Covell's Beach and Bath House

ADA Transition Plan

October 2021

Institute for Human Centered Design

Fig. 2 Accessible picnic table

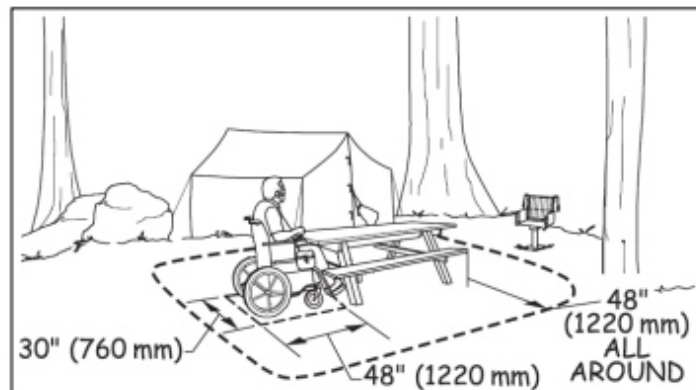
- Recommend providing some benches with backs and some with arms.
- Recommend providing a deeper platform so there's an accessible route and space for two wheelchairs at the seating area at the platform.
- Recommend providing 48" wide stable, firm and slip-resistant surface all around the picnic table. See fig. below.

Fig.3: Accessible outdoor rinsing shower

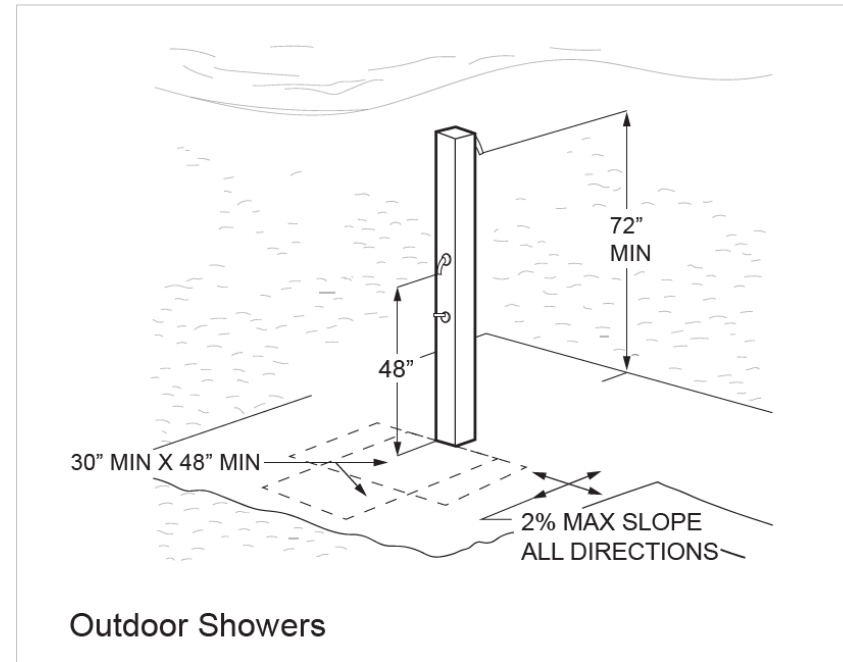
The outdoor rinsing shower lacks a shower head located 48" above the ground and has controls that require tight grasping, pinching or twisting of the wrist. See Fig. 1 at the end of this report for an example of an accessible rinsing outdoor shower.

Urinal												
31	Men's Toilet Room	1		Urinal	N/A		Rim > 17" high Clear floor space not provided at urinal Flush control too high or not properly located	21.25" 34.25" 49.5"	Provide at least one urinal with the rim no higher than 17" above the finished floor. Remove partition to provide a 30" min. by 48" min. clear floor space positioned for a forward approach. Mount flush control at 44" max. above the finished floor.	1	3878	\$3878
Outdoor Rinsing Showers												
32	Outdoor Shower	Ext.		Outdoor Rinsing Showers	N/A		Clear floor space not provided at rinsing shower 2 fixed showerheads not provided	- -	Ensure there is a 30" by 48" clear floor space at the outdoor rinsing shower. Provide two shower heads located 48" and 72" min. above the ground.	1	3119	\$3119
Best Practice

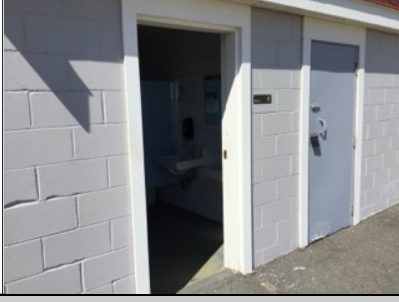
10	Entrance to Beach From Accessible Parking Space	Ext.		Exterior Access Route	Walkway		Route not maintained in operable working condition	-	Ensure the accessible route is maintained in operable working condition.	1	Labor	\$0
